December 10, 2019

**Addendum No. 01
TO THE CONTRACT DOCUMENTS FOR:**

MANSFIELD FIRE STATION NO. 4

KAI Project No. 2016.166

A2.01

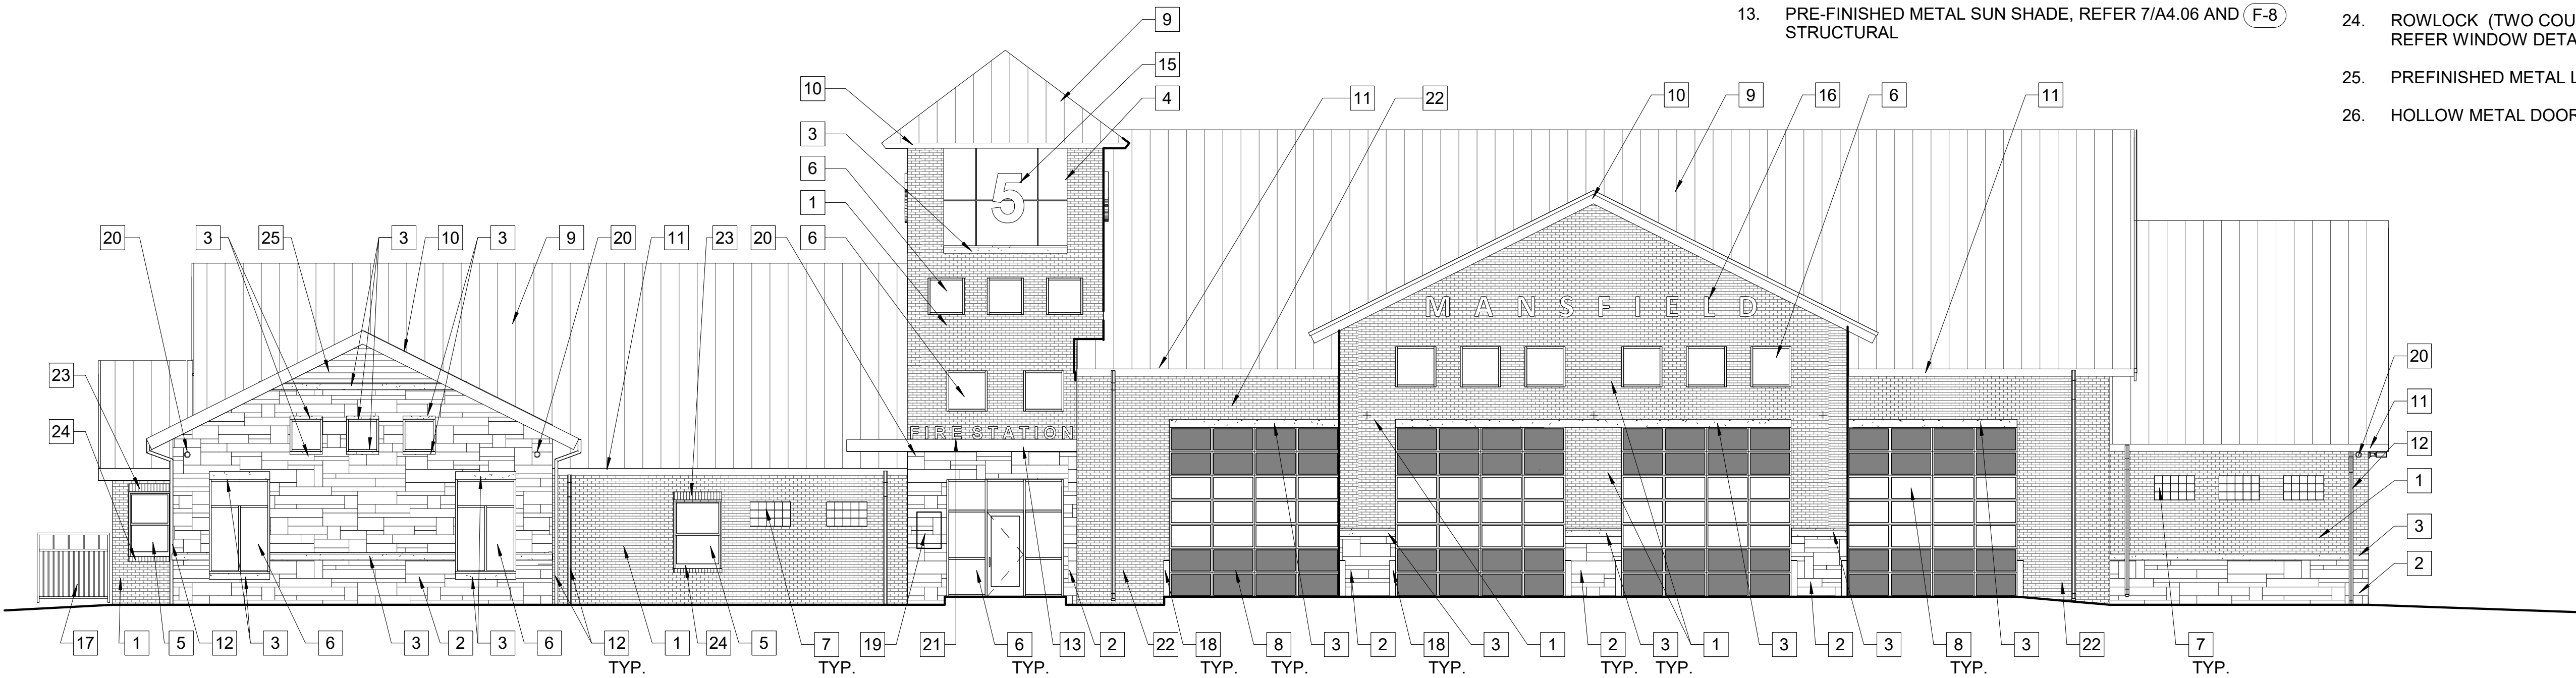
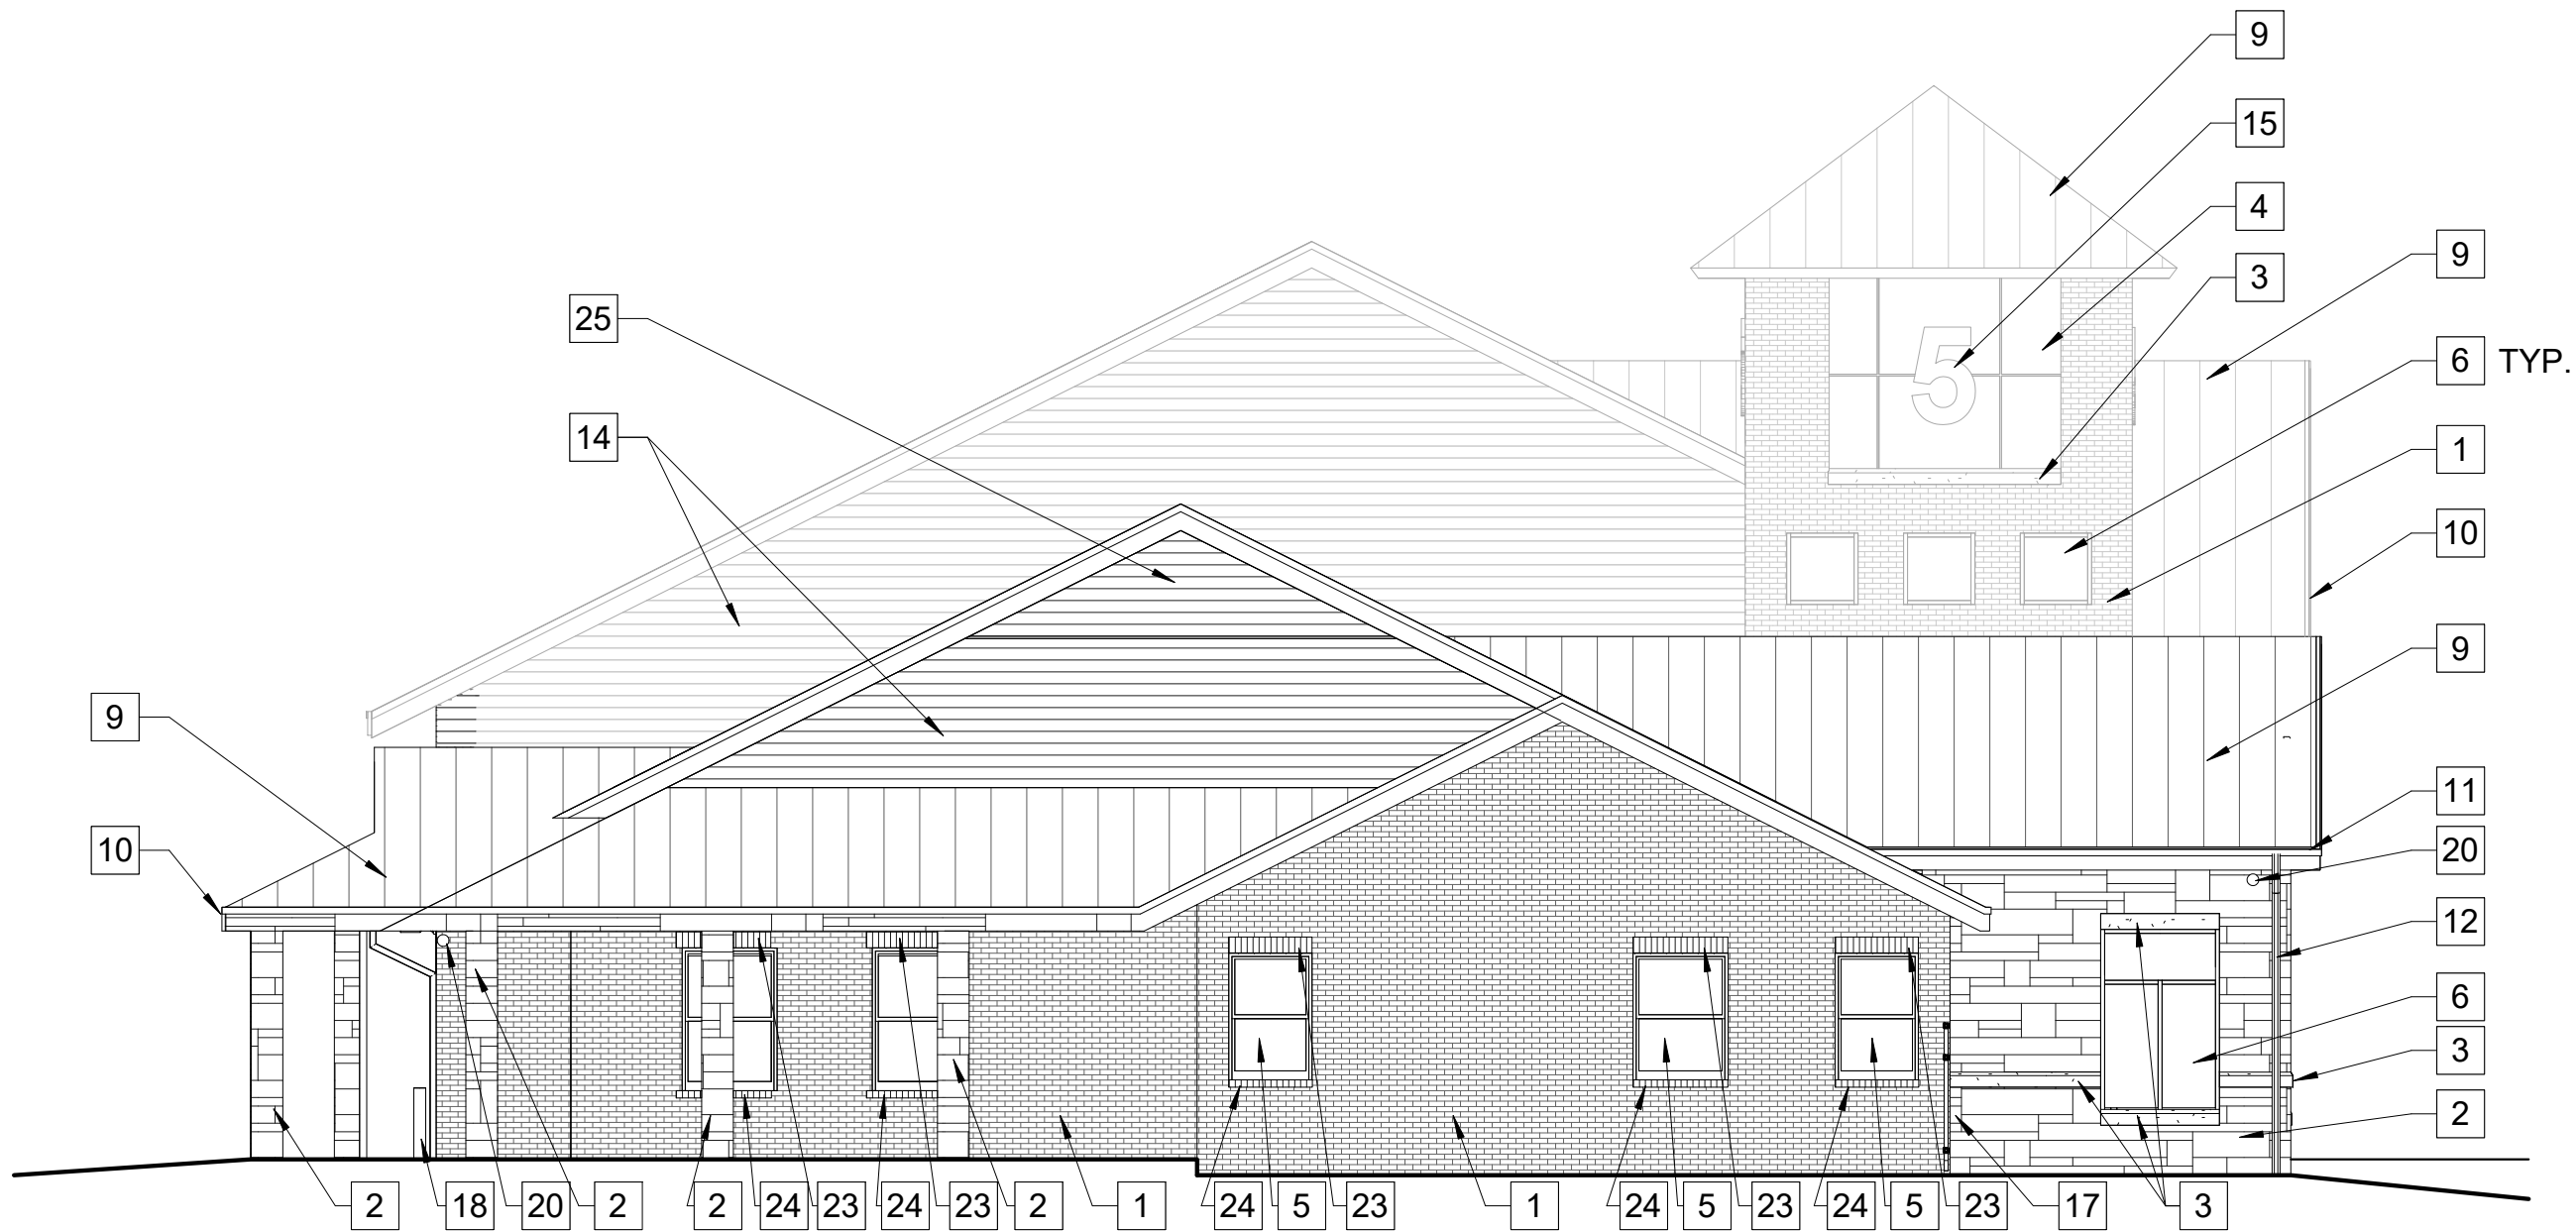
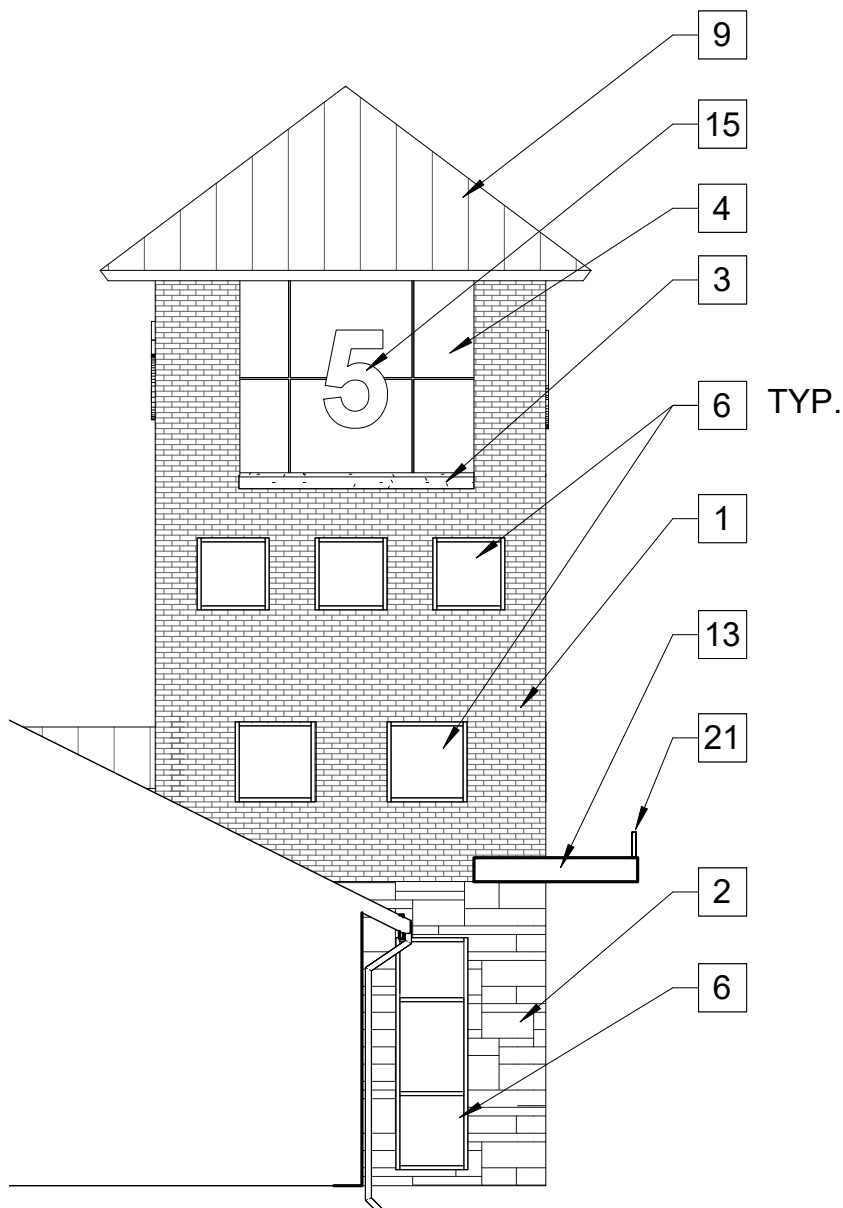
- b. Revised plan 2 to show window type G.
12. Sheet A2.01/A2.02 –
 - a. FINISH LEGEND F-5 Tubelight Slate Gray to be Clear Anodized. Added F-8 – PPG RAL 3011 BROWN RED.

- b. NOTE BY SYMBOL – Note 8 finish revised to F-8.
12. Sheet A4.07 – Detail 5 - Clarification, solid hatch to the right of the CMU wall should not be there.

4
A5.02
1/4" = 1'-0"

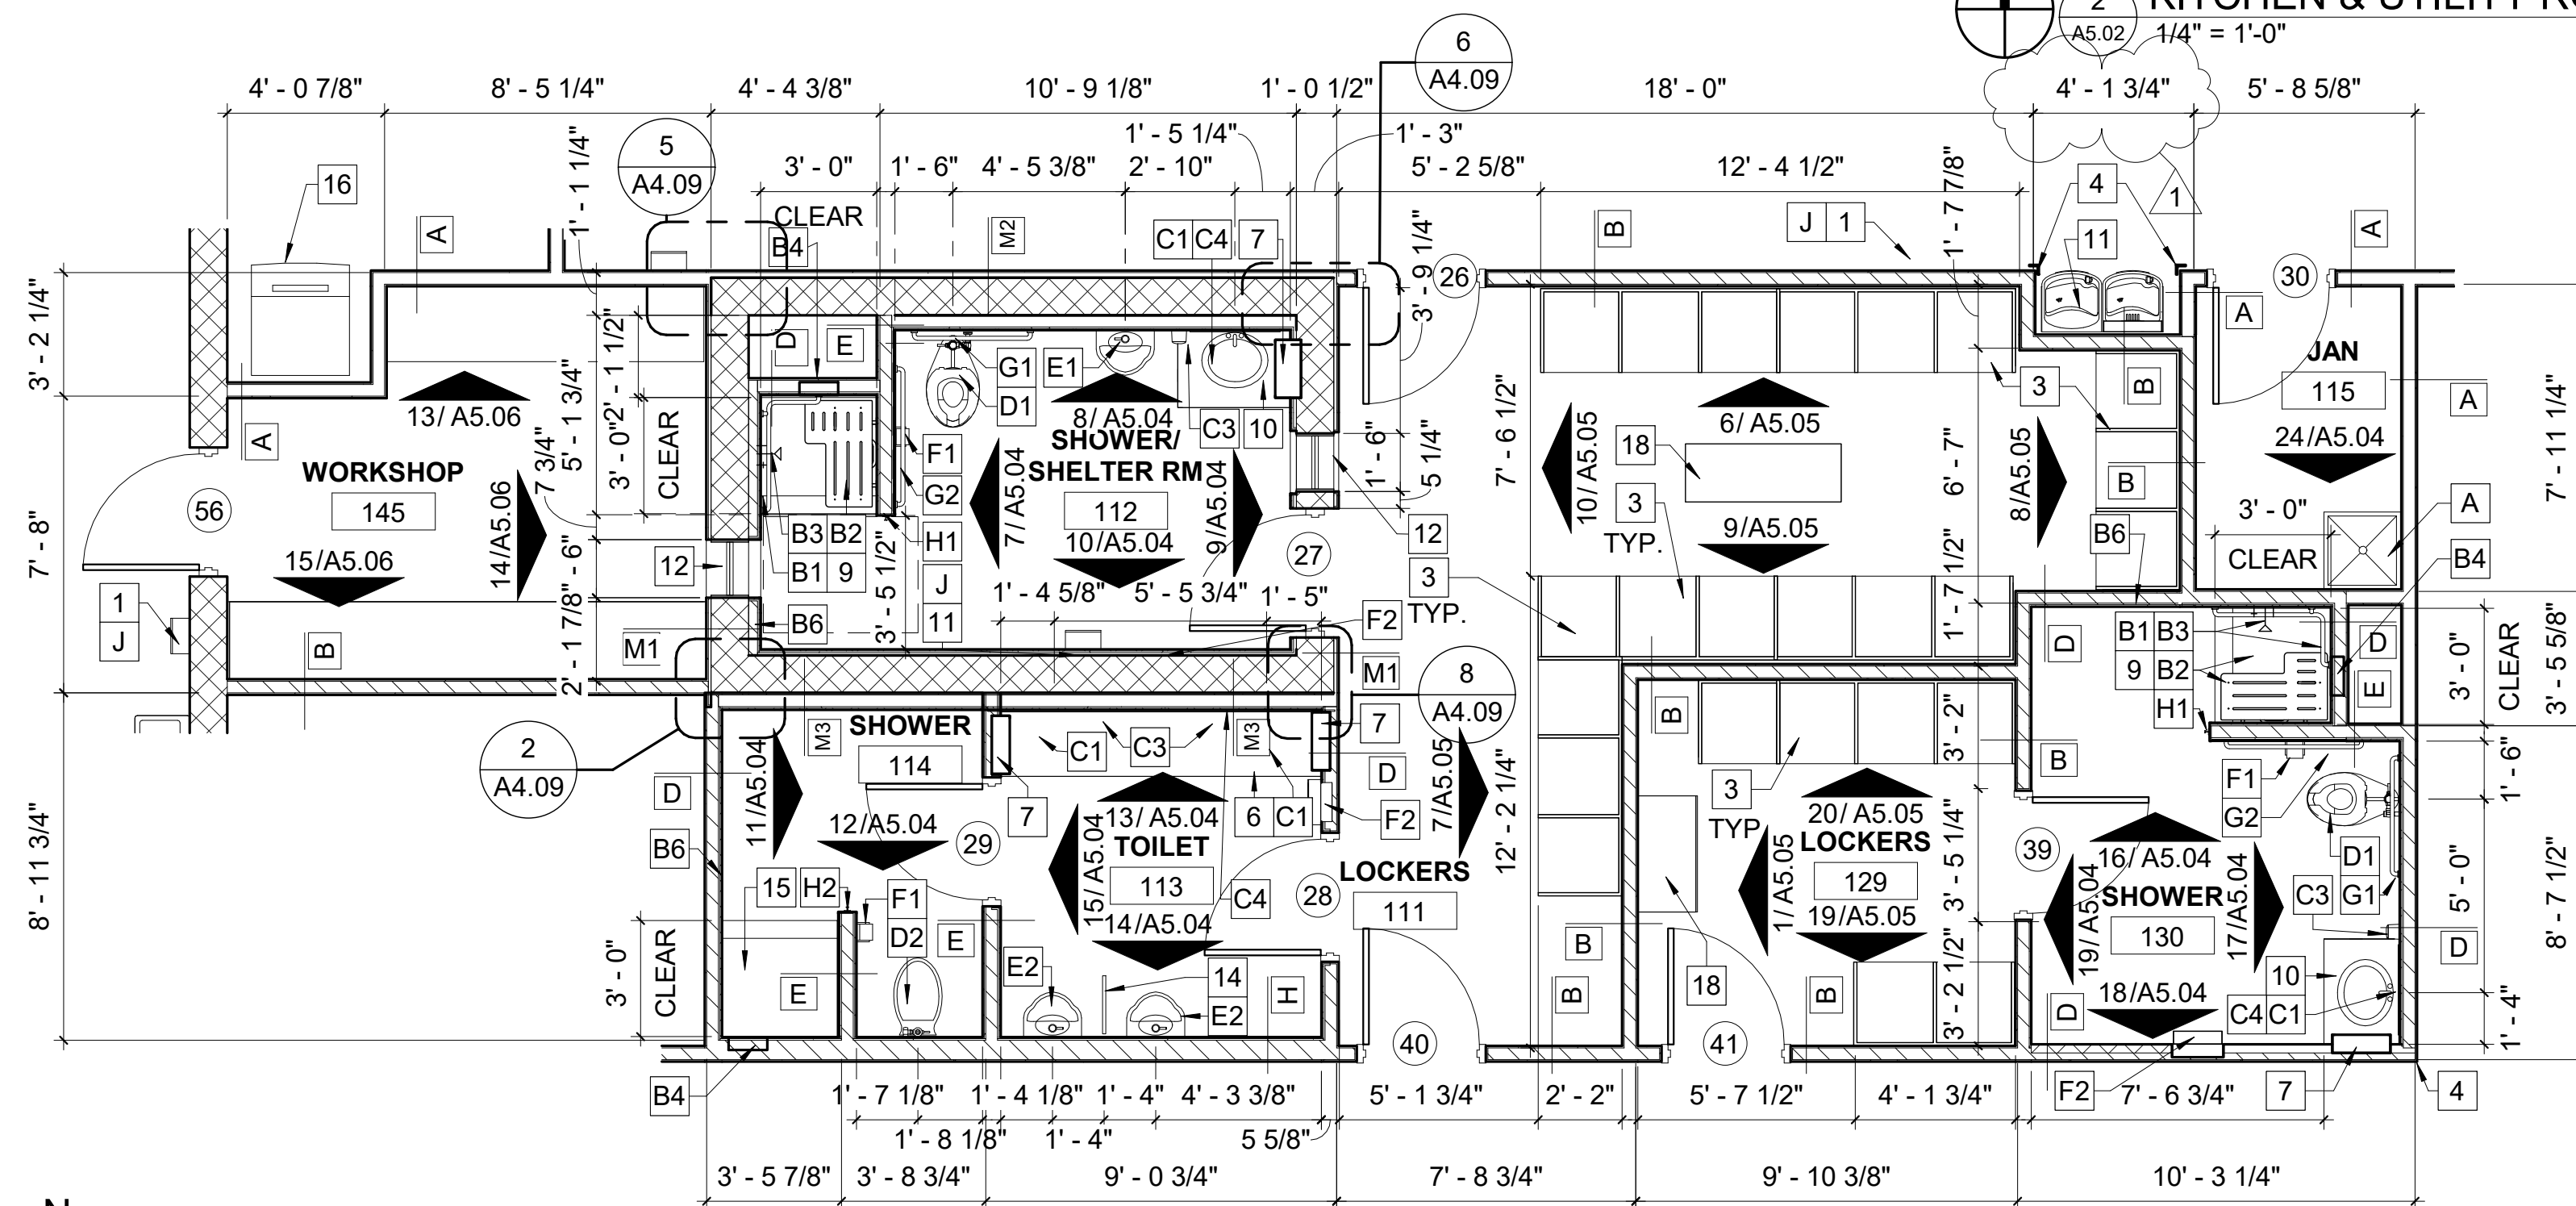
13. Sheet A5.02 – Plan 4 – Revised Electric Water Heater alcove size.
14. Sheet A5.05 – Elevation 5 - Center wall mounted light fixture over mirror.
Elevation 17 – Revised Electric water heater arrangement.
